Exterior Front Door Handle Hard to Open –
Deflection Of Link Rod –
Replace Link Rod

MODEL 2002 MY-ON
X-TYPE

VIN C00001-ON

ILLUSTRATION 1

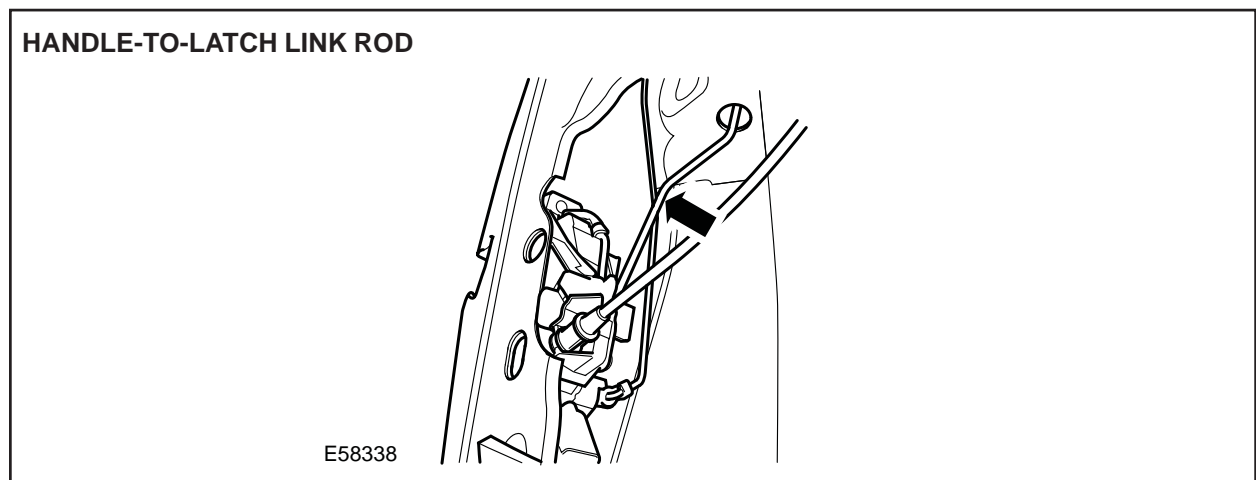
Some 2002 MY-ON X-TYPE vehicles may exhibit a condition where the exterior front door handle may become stiff and eventually become inoperative.

Link rod between the exterior door latch and door handle deflects.

In case of a customer complaint of the above condition, install a new link rod as outlined below.

1. Remove the exterior front door handle (see Global Technical Reference GTR Workshop Manual, section: 501-14, SRO 76.58.01).
2. Install a new exterior door handle to door latch link rod.
